**SUBDIVISION REVIEW SHEET****CASE NO.:** C8-2022-0267.0A**COMMISSION DATE:** February 28, 2023**SUBDIVISION NAME:** Resubdivision of Lot 1-A**ADDRESS:** 11801-1/2 Research Blvd Service Road**APPLICANT:** Karlin Duval, LLC (Matthew Schwab)**AGENT:** HRGreen Development TX (Joe Isaja)**ZONING:** LI, LI-CO (Limited Industrial)**NEIGHBORHOOD PLAN:** n/a**AREA:** 53 acres**LOTS:** 8**COUNTY:** Travis**DISTRICT:** 6**WATERSHED:** Walnut Creek**JURISDICTION:** Full Purpose**SIDEWALKS:** Sidewalks along state-maintained property must be approved by TxDOT.**VARIANCE:** None**DEPARTMENT COMMENTS:**

**CITY OF AUSTIN –DEVELOPMENT SERVICES DEPARTMENT  
SUBDIVISION APPLICATION – MASTER COMMENT REPORT**

CASE NUMBER: C8-2022-0267.0A  
UPDATE: U4  
CASE MANAGER: Nicholas Coussoulis

PROJECT NAME: Resubdivision of Lot 1-A  
LOCATION: 11801-1/2 RESEARCH BLVD SVRD NB

**Overall Wetland CEFs:**

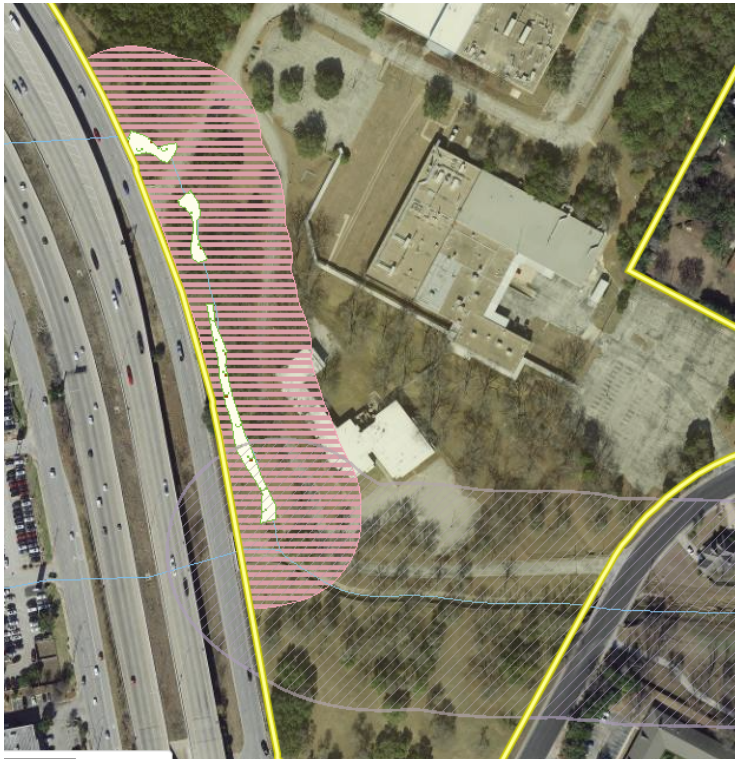
FYI Three wetland CEFs (BRG IDs 207775, 207776 and 207777) were previously identified and field verified by WPD staff. These three CEFs coincide with the wetland CEFs identified in the ERI conducted by Terracon (dated July 2019). Please the screenshots of the approximate location and boundaries of the wetland CEFs on Property Profile Tool. In addition, the Shapefiles for the wetland CEFs are available on Property Profile to be downloaded.

**WB1. Update0.** Please demonstrate compliance with LDC 25-8-281 or 30-5-281; LDC 25-8-282 or LDC 30-5-282.

Additional information: {This reviewer cannot establish wetland CEF protection provisions. e.g. Clearly show the boundary of the wetland CEFs and clearly label the features: "WETLAND CEF"

on all plat sheets where they exist. Please show the wetlands as shown in the Environmental Resource Inventory and on Property Profile Tool see screenshots above.}

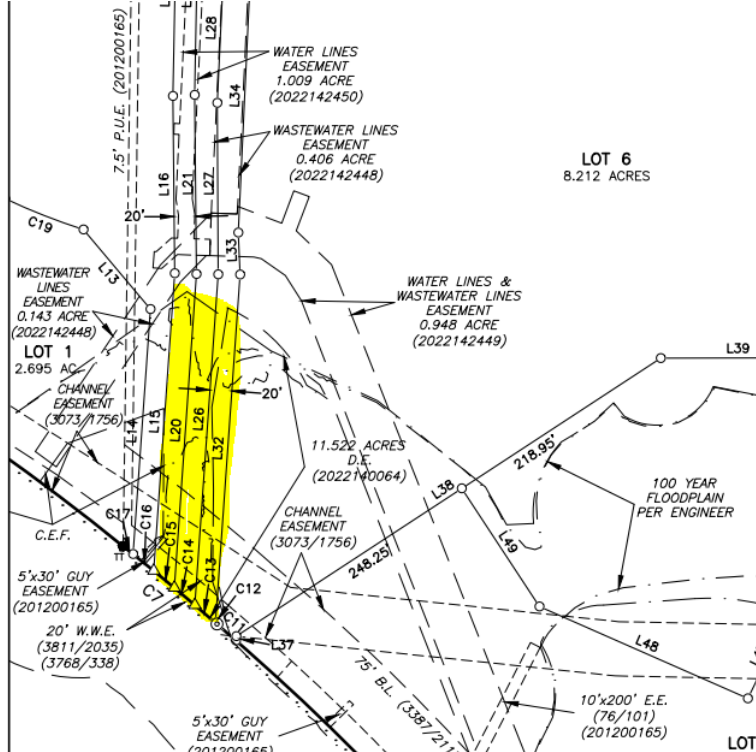
**Update1. Repeat comment.**

- a) Clearly show and label the wetland CEFs as stated above.
- b) Remove the modified wetland CEF setback from the plat.
- c) The proposed water and wastewater line easements (highlighted in yellow in the screenshot below) appear to be bisecting/crossing one of the wetland CEFs. If this is accurate, the encroachment of these easements was not incorporated in the approved wetland CEF mitigation plan for SP-2021-0108D and additional 1:1 mitigation pursuant to ECM 1.10.4 will be required for this additional encroachment/impact to the wetland CEF and associate CEF setback.

**Update2. Comment partially addressed: Informal comment.**

- a) Comment partially addressed: Informal comment (Wetland CEFs are clearly shown and labeled as CEF.) Please revise labels from “CEF” to “Wetland CEF” and ensure the labels are not covered by other labels on the plat.
- b) **Comment cleared. (The modified wetland CEF setback has been removed from the plat.)**
- c) **Comment cleared. (It has been clarified that the proposed water and wastewater line easements are located within the existing driveway and do not require additional 1:1 mitigation pursuant to ECM 1.10.4.)**

**Update3. Comment cleared.**

- a) Comment cleared. (The labels have been revised from “CEF” to “Wetland CEF” and have been moved so they are not covered by other labels on the plat.)
